URGENT Field Safety Notice

Allura Xper, Allura Centron, and Azurion systems
Potential loss of imaging functionality resulting from no or intermittent X-ray radiation initiation through the wired foot switch.

27-October-2023

Reference: 2023-IGT-BST-004: Allura Xper, Allura Centron, and Azurion Systems.

Figure 1: AD7XT and AD7XNT Patient Table

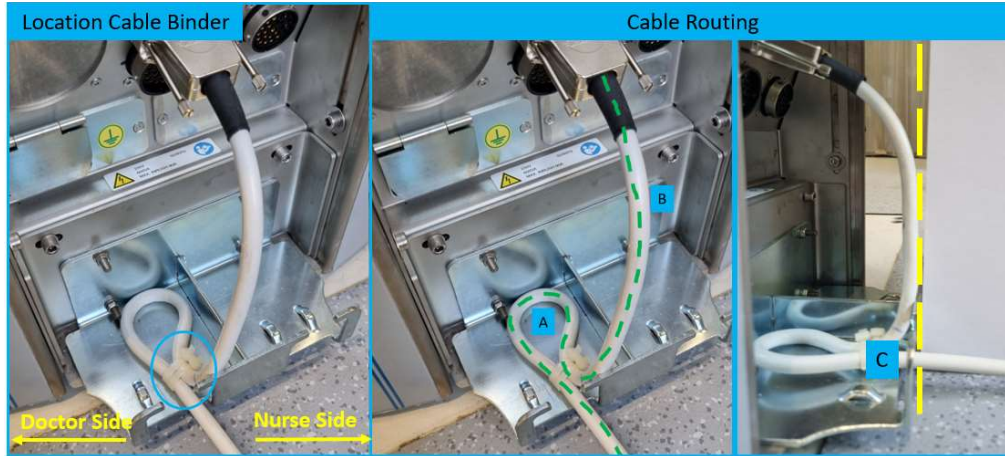
- Cable binder used for strain relief:
 - Type of cable binder(s)
 - Number of cable binder(s)
 - Position of cable binder(s)
- Cable routing (depending on picture indicated with "A" "B" "C")
- For AD7NT, there are 2 possibilities for strain relief:
 - Strain relief by means of bushing (Figure 4a)
 - Strain relief by cable binder (Figure 4b)
- For correct routing and strain relief, see Figures 1-6 below.

Number of cable binder(s): 2 (two)

If strain relief or routing is not correct, repair according to the repair instructions.

Figure 2: AD7XT and AD7XNT Auxiliary OP Rail Patient Table Strain Relief

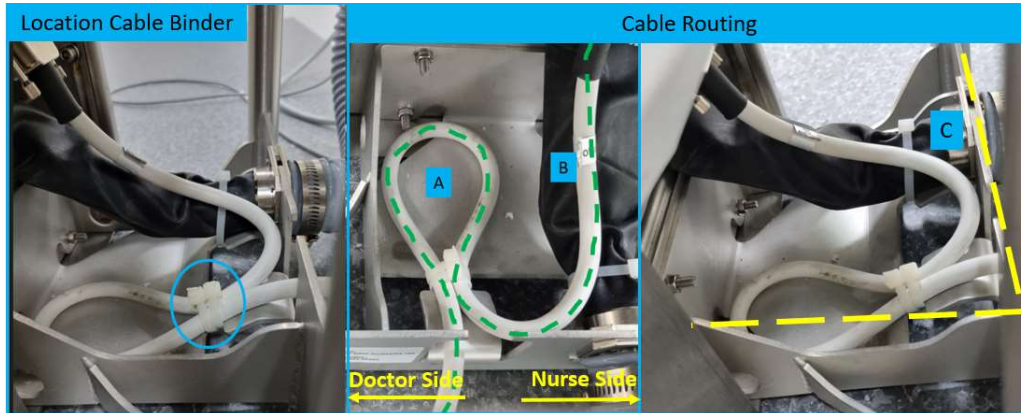
Number of cable binder(s): 2 (two)

Figure 3: AD7 Patient Table

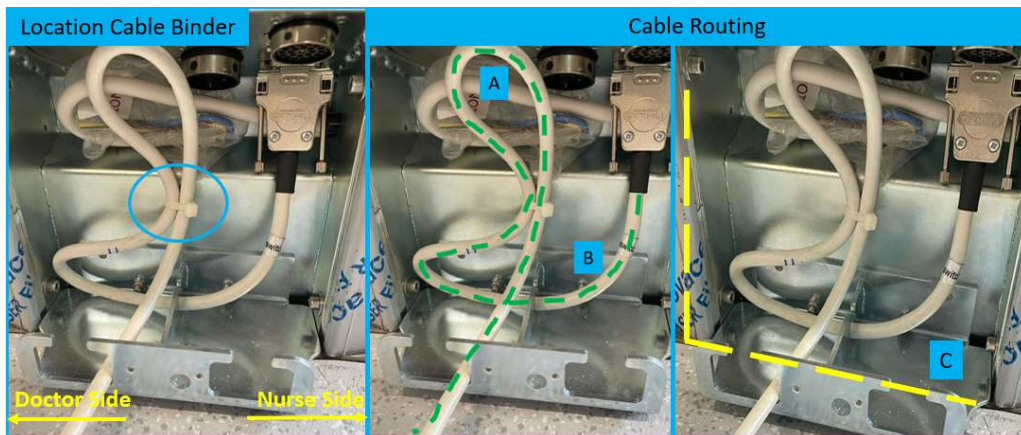
Number of cable binder(s): 1 (one)

Figure 4b: AD7NT Patient Table with cable tie strain relief

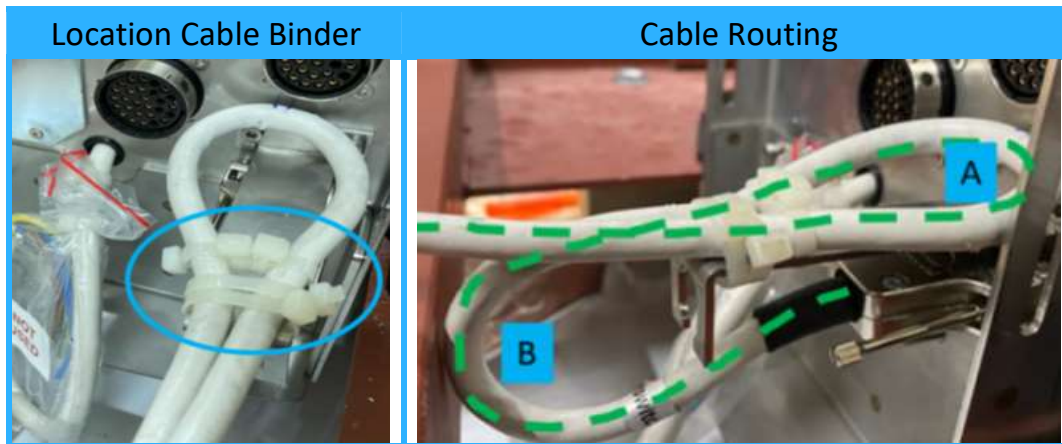
Number of cable binder(s): 5 (five)

Figure 5: Pedestal Wall Connection Box

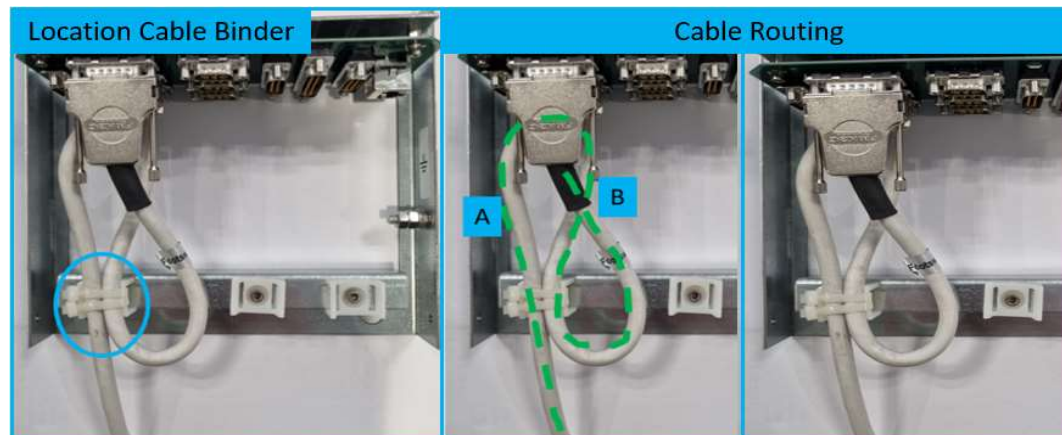
Number of cable binder(s): 2 (two)

Figure 6: Surgery Wall Connection Box

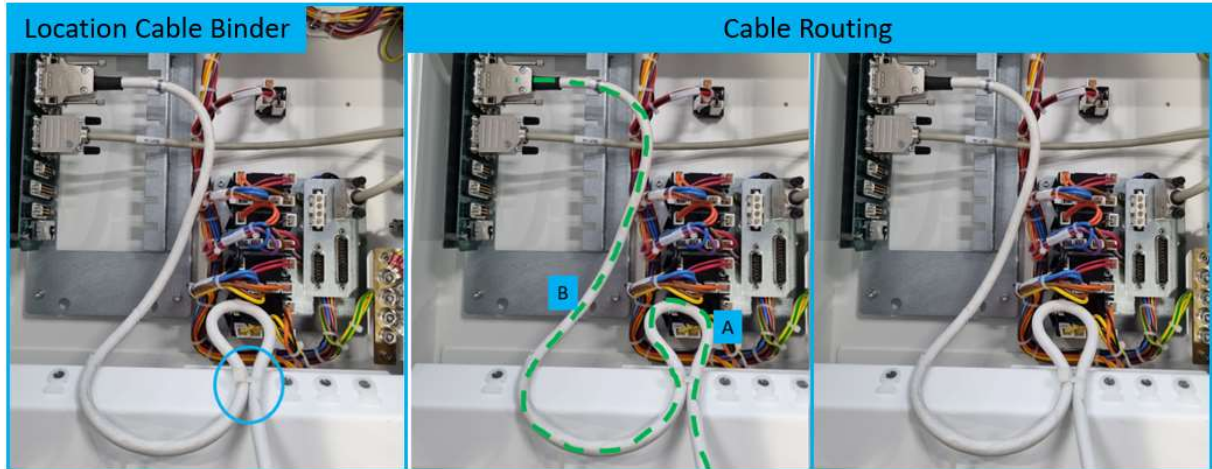
Number of cable binder(s): 1 (one)

Figure 7: Non-swivel table (AD7NT, AD7XT and AD7XNT)

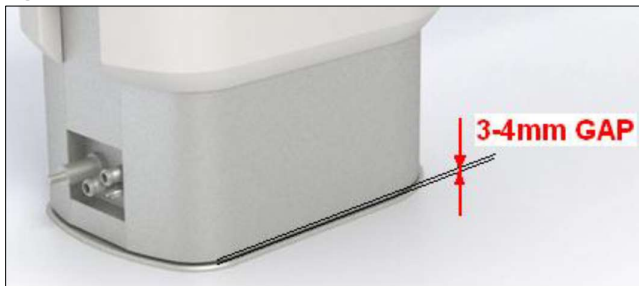
Check the clearance of the plinth cover:

- For a non-swivel table
 - Make sure that the clearance to the fluid protection plate is 3-4 mm
 - Refer to Figure 7
- For a swivel table
 - Make sure that the clearance to the swivel cover is 3-4 mm
 - Refer to Figure 8

If the gap between the plinth covers and the floor does not satisfy the above requirement, adjust the plinth cover according to the repair instructions.
